# PREDICTED DRAWDOWN

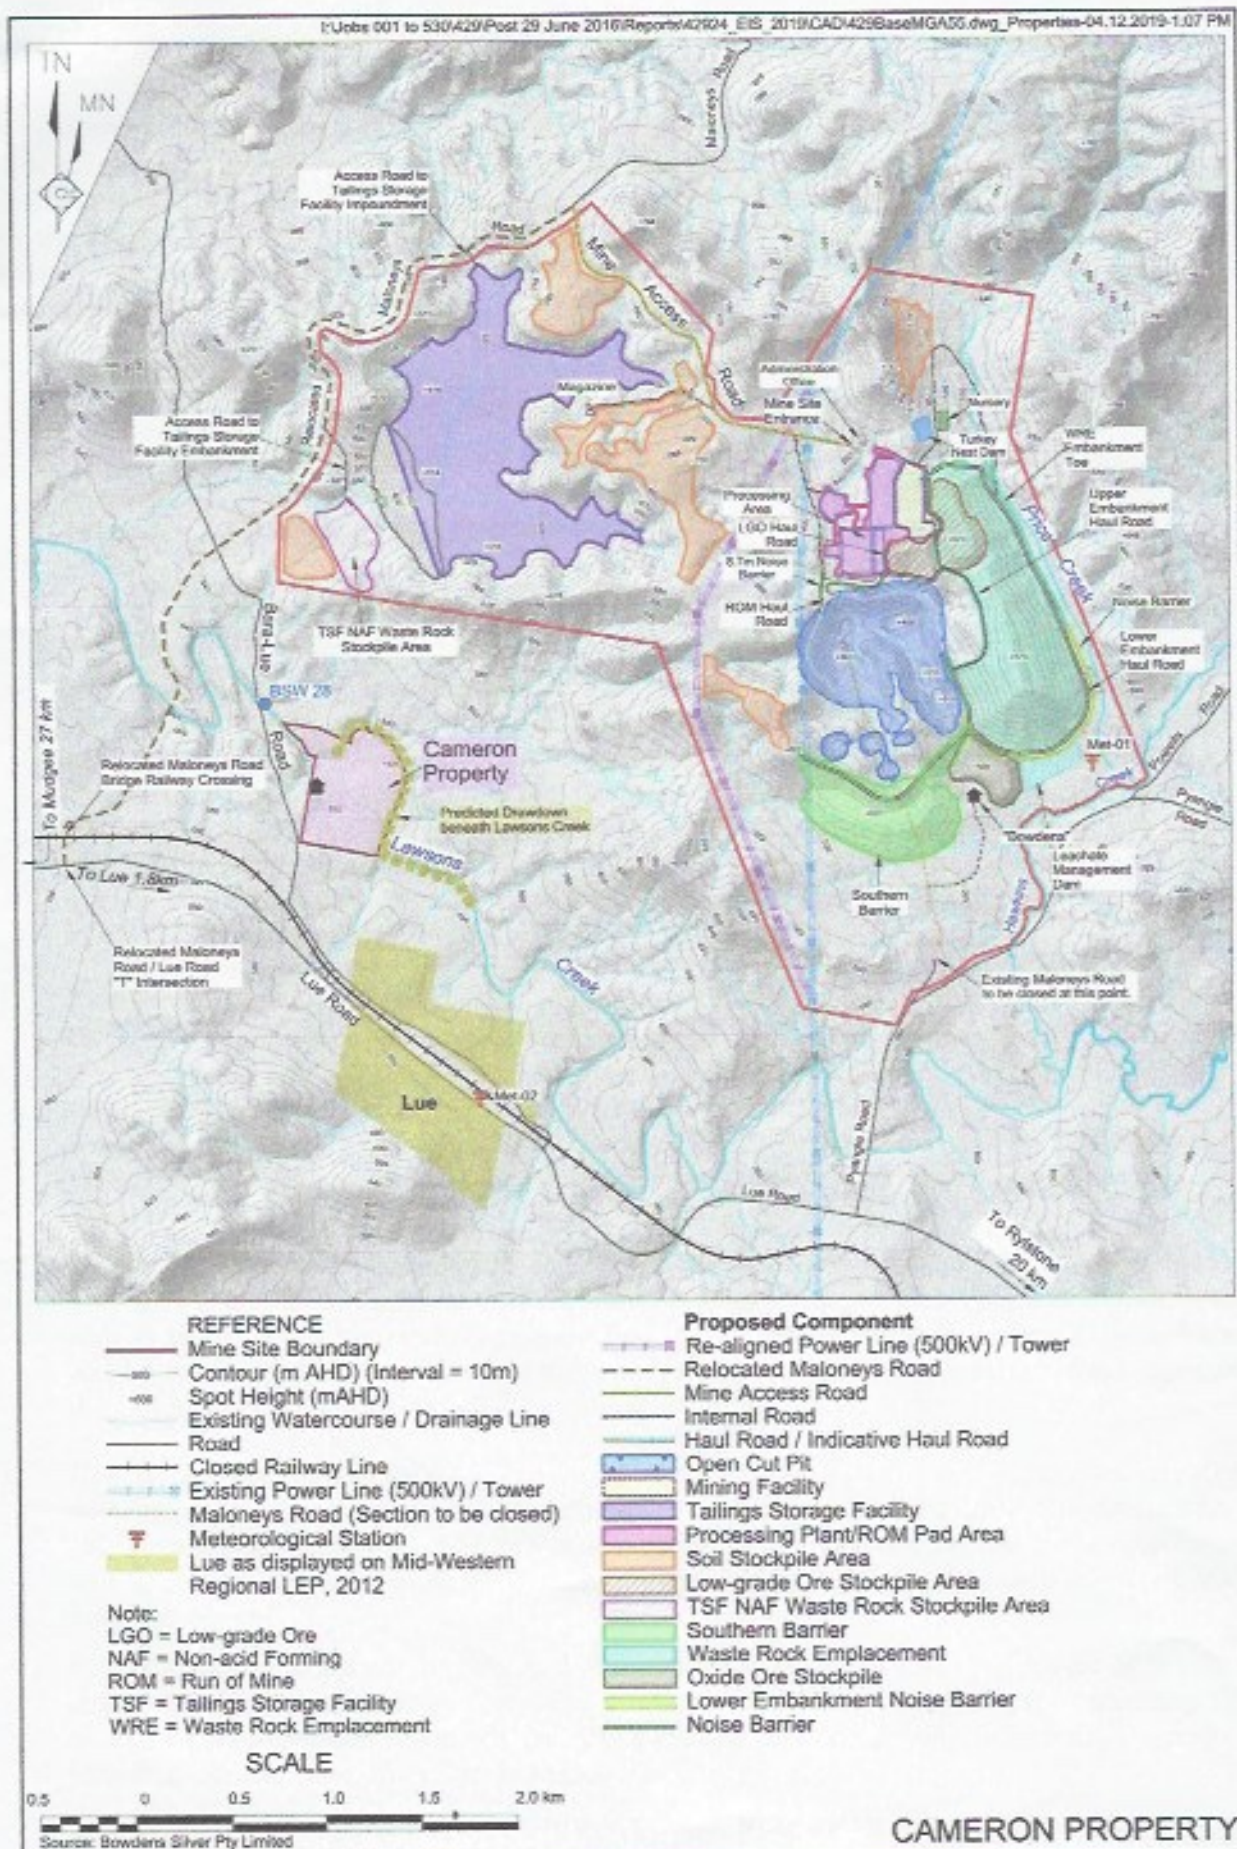
22. New question: 15 MAP reference "PREDICTED DRAWDOWN BENEATH LAWSONS CREEK" Please explain exactly what this notation on your map means, as I note from the map that it runs the whole length of the creek running through my property.

The groundwater assessment has predicted drawdown of the groundwater table that would impact groundwater beneath Lawsons Creek in the vicinity of your property. This is predicted

to reduce the contribution of groundwater to the creek in that location (referred to as a baseflow reduction). The existing flows in Lawsons Creek are such that this impact would not generally be noticeable, except in extremely dry situations where the Lawsons Creek is reduced to pools. Where groundwater is contributing to the depth of these pools a decrease to the depth of these pools would be noticeable. This would be a rare occurrence given the more regular flows in the creek. We also acknowledge that the recent dry conditions have reduced flows in Lawsons Creek, however these are not considered normal conditions and hopefully we soon see an end to the drought conditions experienced over the last few years.
